FV430 SERIES VEHICLES, ALL MARKS

GENERAL INSTRUCTION NO. 2

SUBJECT: Gear selector mechanism

Fig 1 Gear selector mechanism

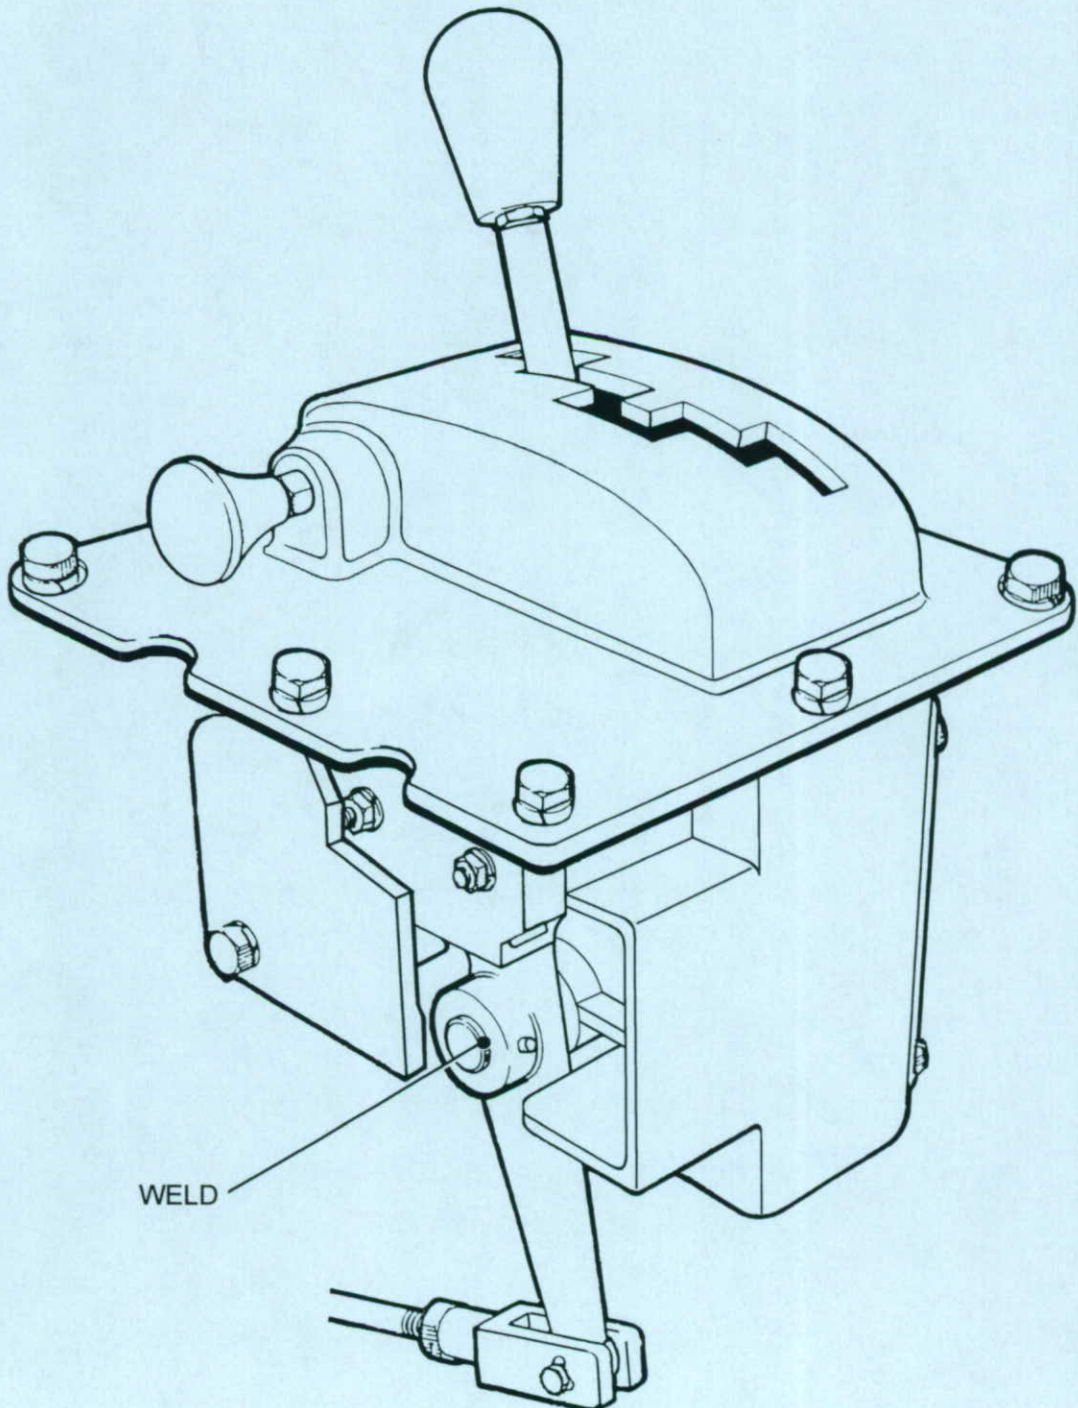
1 To overcome wear of the gear selector mechanism and the failure of the roll pin retaining the output lever to the shaft, the gear selector output lever is to be welded to the shaft.

8.3 Weld, to current regulations, the output lever to the shaft.

8.4 Whilst firmly holding the gear input lever in 3-6 range, check the output lever for movement. None is permitted. Ensure full and correct range of movement of the gear selector mechanism.

Fig 1 Original and new type cable and fittings

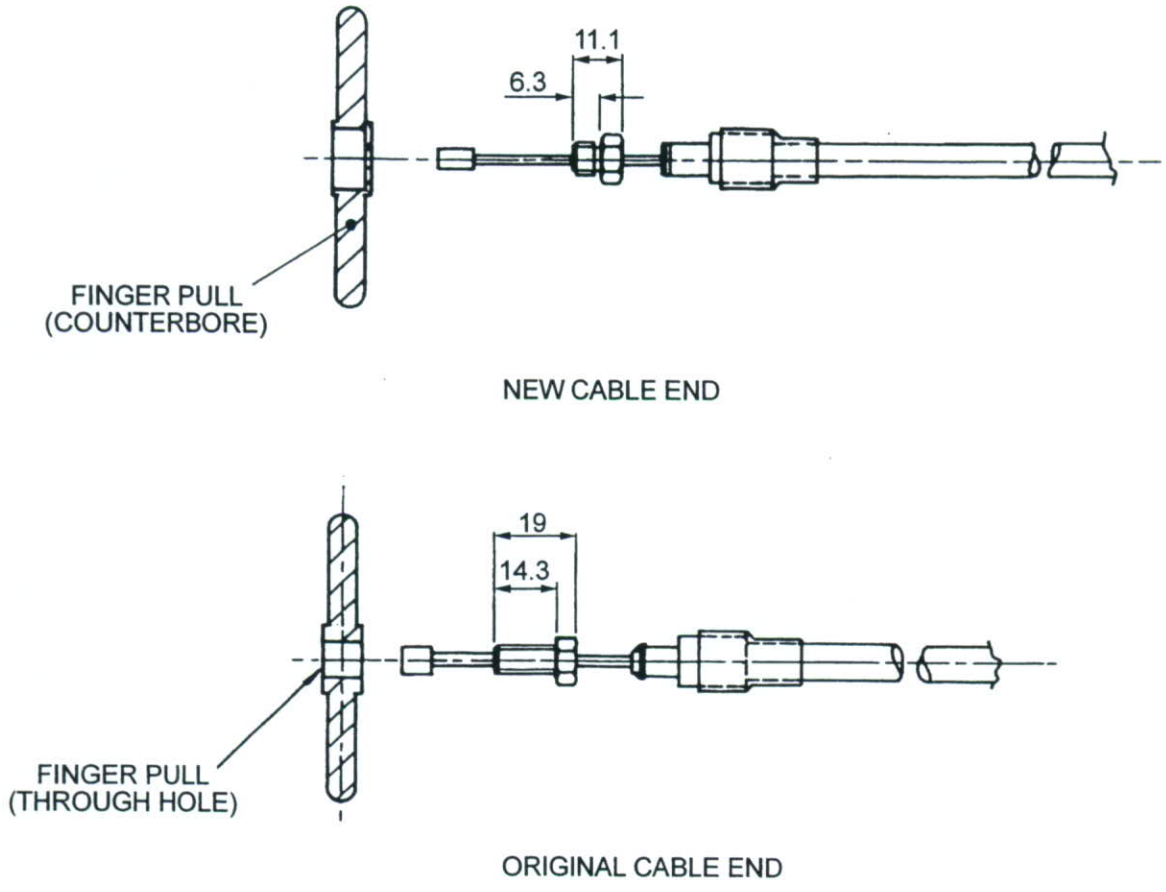
1.1 Recent specification changes to FV 430 fixed fire extinguisher system operating cables have resulted in a new design of cable, which will be issued as a routine replacement. The change is common to all cables, fitted to any FV 430 series vehicle, and affects the end fitting and finger pull at the extinguisher manifold/mounting bracket.

8.1 Note the differences between the finger pulls and the cable ends of the original cable and the new cable. Although either type of fixed fire extinguisher cable can be fitted, the finger pulls are not interchangeable between cable types, and must be kept with the cable that it has been manufactured to fit. The finger pull that is supplied with the new type of cable must only be fitted to the new type of cable.

8.2 Adjust the fire extinguisher cables by first setting the lower junction box adjusters to the mid position. Adjust the junction box upper adjusters evenly until the pin in the long hexagon of the discharge head begins to move, tighten locknuts. Adjust the cables to give 3.2 mm free play on the remote controls, which will also give 3.2 mm freeplay on the external handles.

Fig 1 Driver's compartment, forward right corner (instrument panel removed for clarity)

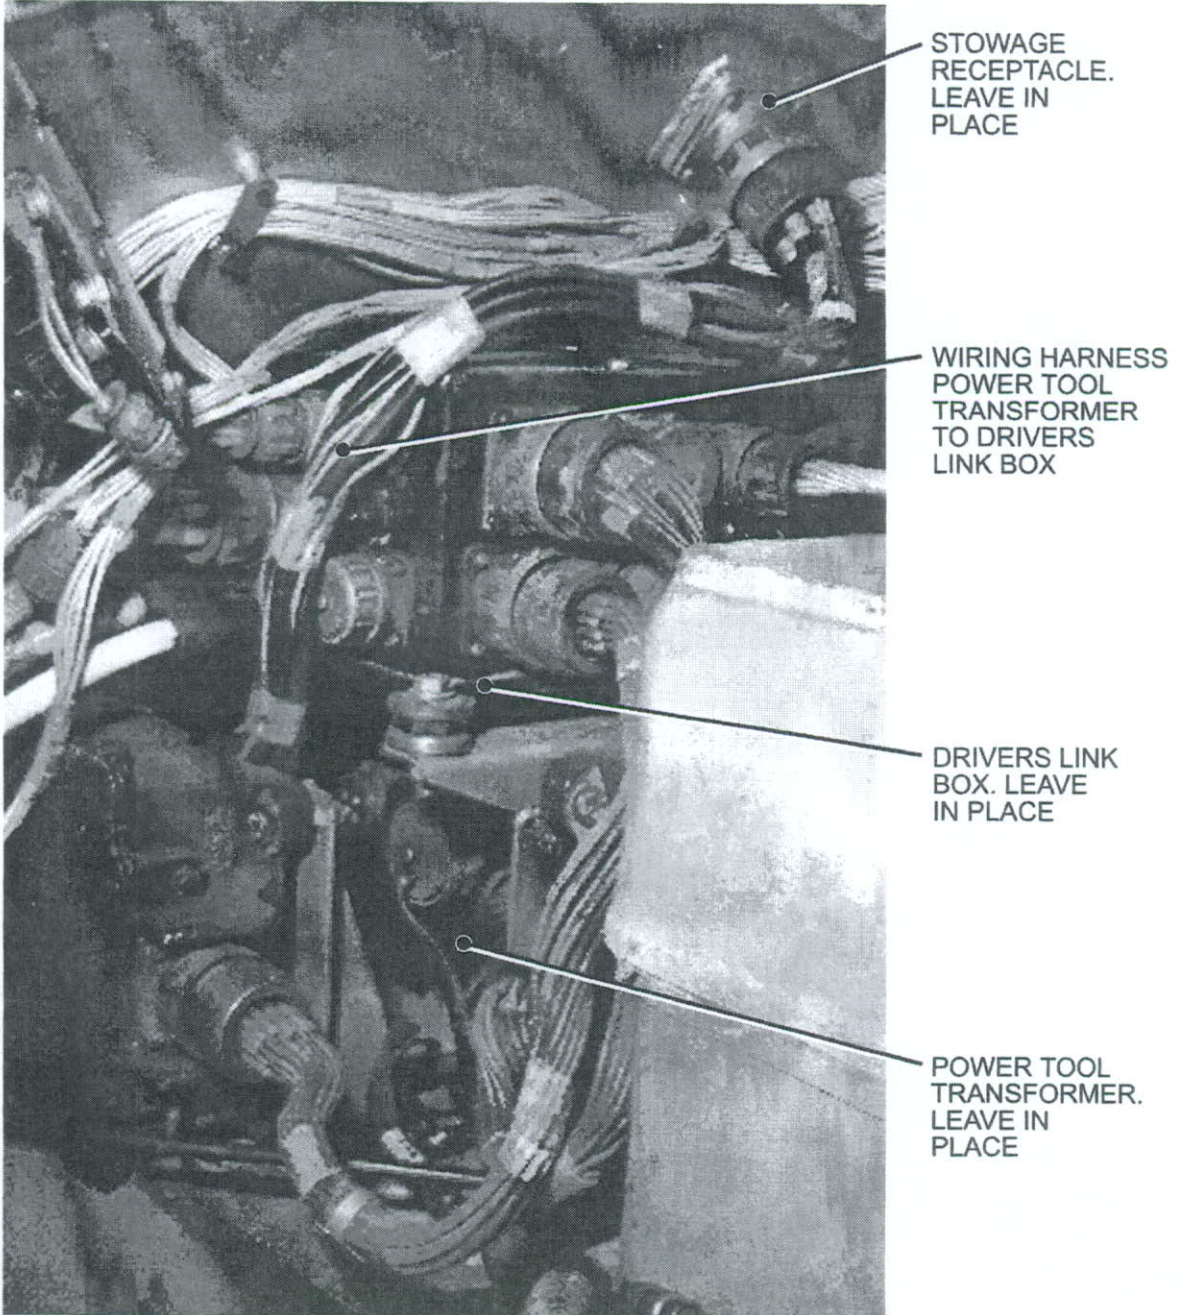
1 To remove the cable that is used to supply power from the drivers link box to the power tool transformer. All FV430 series vehicles power tools were removed from use under the authority of DCI 27/92 and DCI 70/94. The power tool transformer and all other associated cabling and output sockets will be removed during base overhaul.

9.1 Remove cable (item 1) and dispose of locally.

Fig 1 Front upper mounting bracket

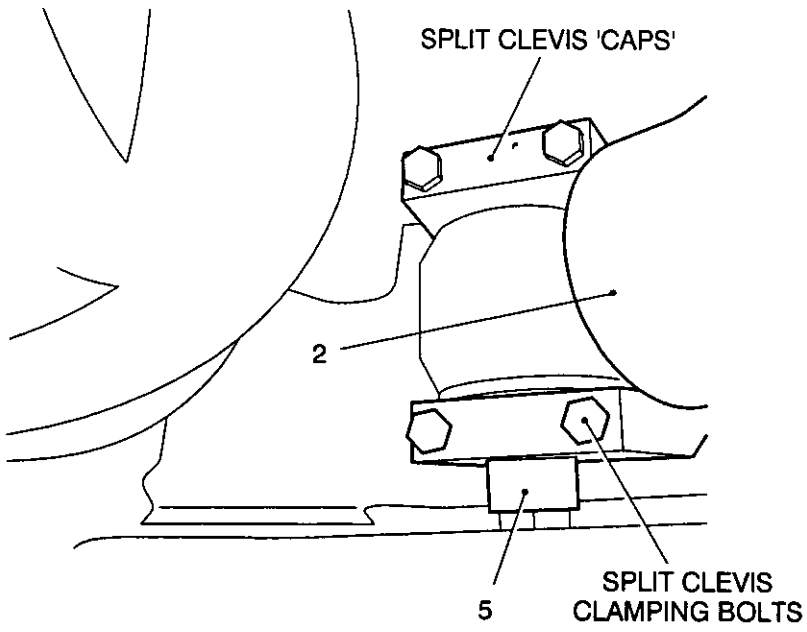
9 Slacken the upper bracket-clamping bolt (Fig 1) and remove the existing damper top mounting pin and discard. Retain the top pin nut, if the nut is damaged fit a new nut NSN 5310-99-866-6962.

13 Place the replacement damper (Item 2) upper mounting in position in the upper mounting bracket (Fig 1) with the nameplate facing outward. Fit the top-mounting pin (Item 3) through the upper mounting as shown and screw fully in using a 1⁵/₁₆ in. socket until the damper mounting inner sleeve is fully clamped. Retighten the upper bracket-clamping bolt.

retain top pin nut, if nut is damaged fit new nut NSN: 531099-866-6962.

Note: Removal and refitting of top pin is improved if outer mounting bracket is unbolted from final drive flange.

Fig 2 Split Clevis lower mounting

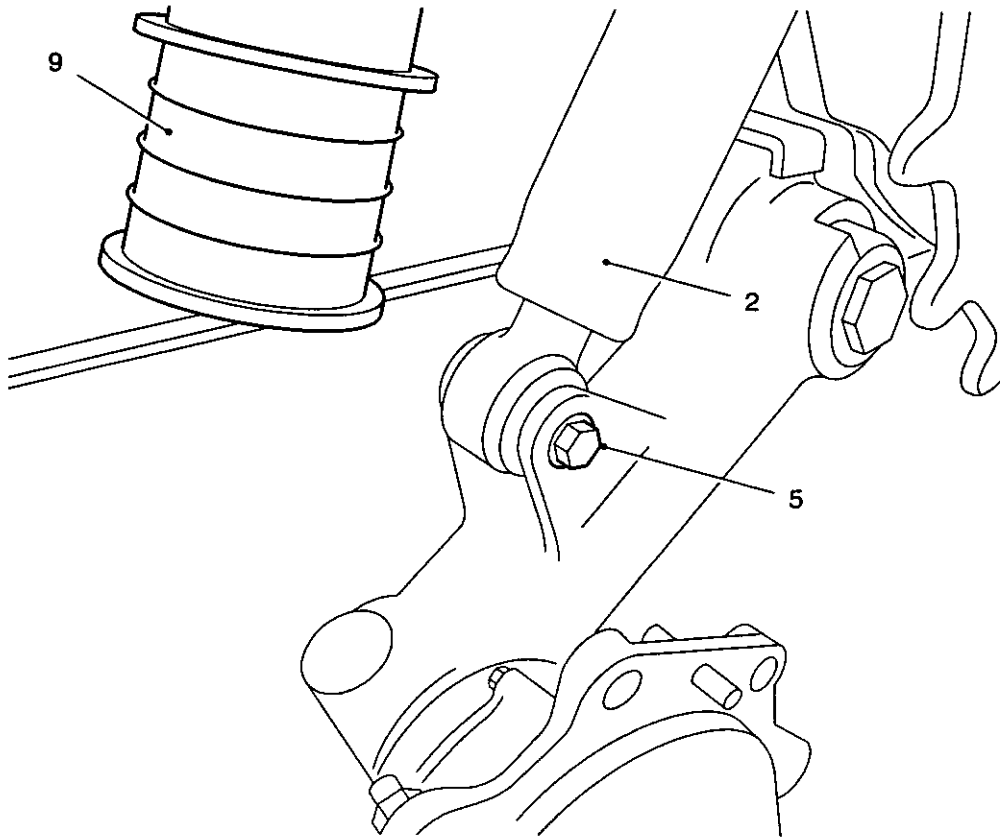
9.2 If the trailing arm does feature a split clevis damper mounting arrangement, slacken and remove the bolts retaining the upper caps of the split clevis to the trailing arm (Fig 2). Identify which upper clevis half was fitted to which part of the clevis mounting before removing them from the trailing arm.

19.2 If the trailing arm does feature a split clevis damper mounting arrangement, slacken and remove the bolts retaining the upper halves of the split clevis to the trailing arm (Fig 2). Identify which upper clevis half was fitted to which part of the clevis mounting before removing them from the trailing arm.

Fig 3 Standard (Non split) Lower mounting brackets

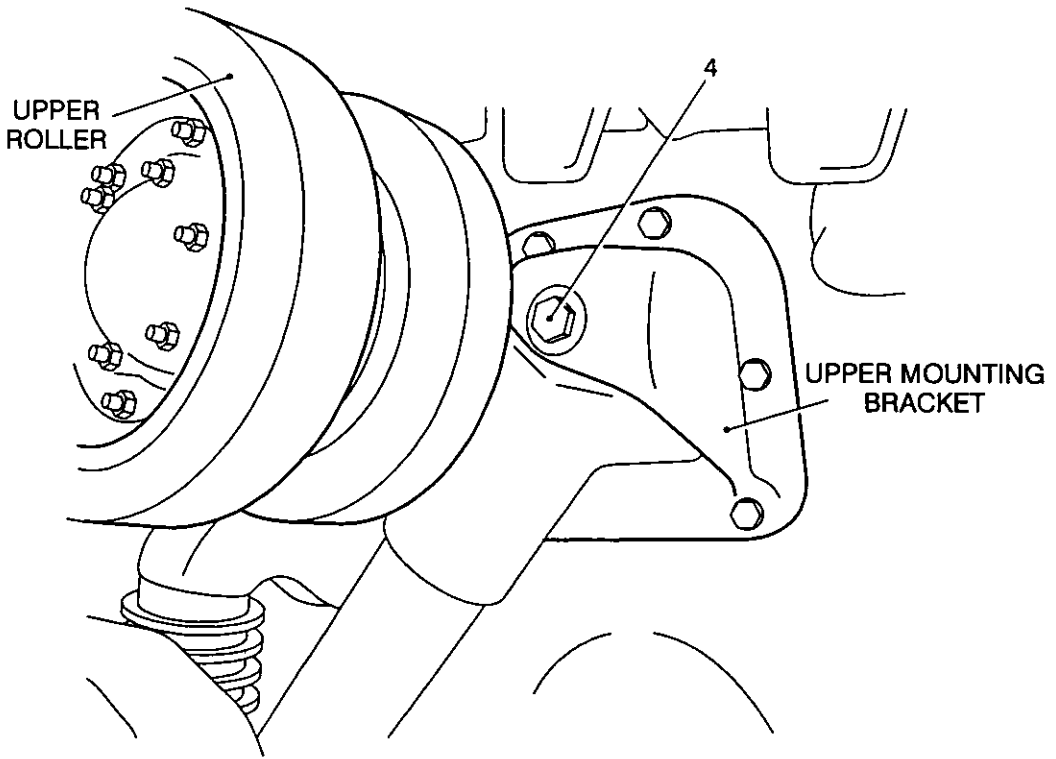
15 If the trailing arm lower mounting is not of the split clevis type, offer the damper lower mounting bush into the trailing arm clevis and fit mounting pin (Fig 3(5)). Screw the pin fully home (i.e. damper bush inner sleeve clamped) and fit a new UNF lock nut to the protruding inner thread of pin (Item 5).

21 Slacken and remove the 3/4 in. UNF nut securing the existing bump stop assembly (Fig 3) to the bump stop mounting bracket and remove the bump stop (Item 9). Clean loose dirt/corrosion away from the bump stop bracket-mounting hole.

25 If the trailing arm lower mounting is not of the 'split clevis' type, offer the damper lower mounting bush into the trailing arm clevis and fit mounting pin (Fig 3, Item 5). Screw the pin fully home (i.e. damper bush inner sleeve 'clamped') and fit a new $\frac{5}{8}$ in. UNF lock nut to the protruding inner thread of pin.

Fig 4 Rear Damper top mounting bracket

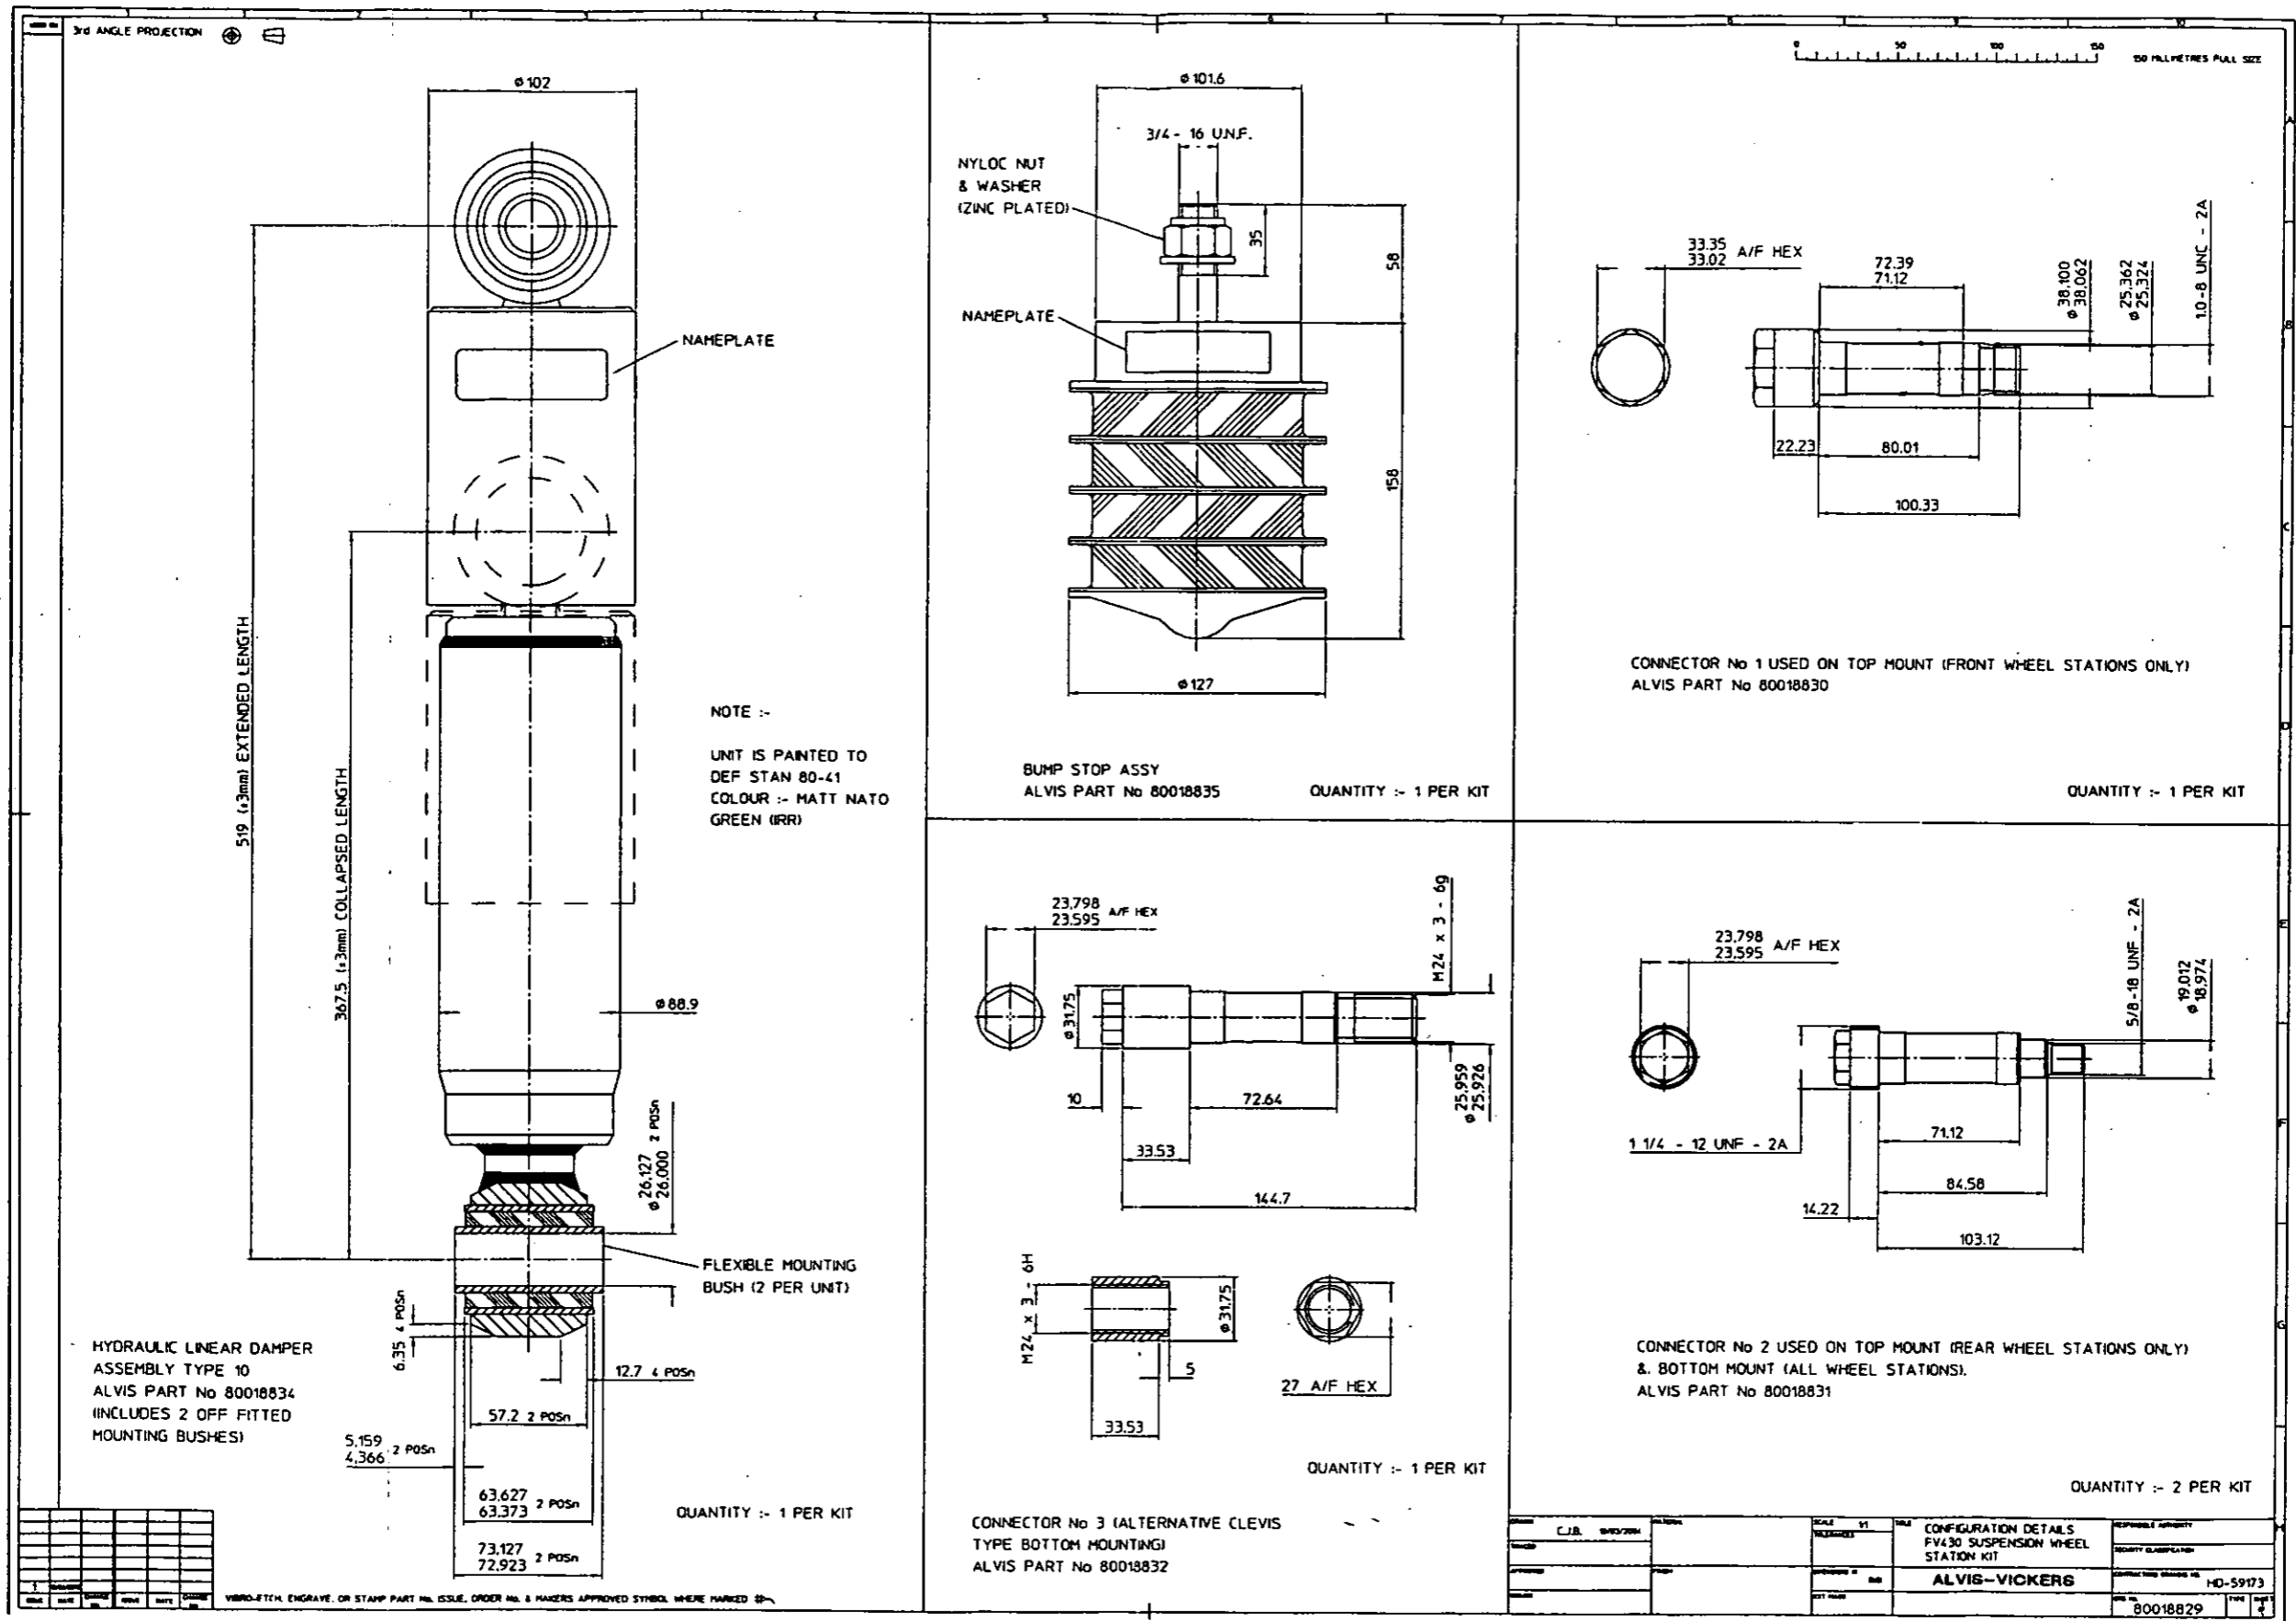
23 Place the replacement damper (Item 2) upper mounting in position in the upper mounting bracket (Fig 4) with the nameplate facing outward. Fit the top-mounting pin (Item 4) through the upper mounting and screw fully in using a $\frac{15}{16}$ in. A/F socket until the damper mounting inner sleeve is fully clamped. Fit a new shallow UNF lock nut (Item 12) to the protruding inner thread of the pin (Item 4) and check for thread protrusion through the nylock nut.

Fit a new UNF lock nut to the protruding inner thread of pin (item 4).

Fit a new shallow UNF lock nut NSN 5310 99 137 0580 to the protruding inner thread of pin (item 4) and check for thread protrusion through nylock nut.
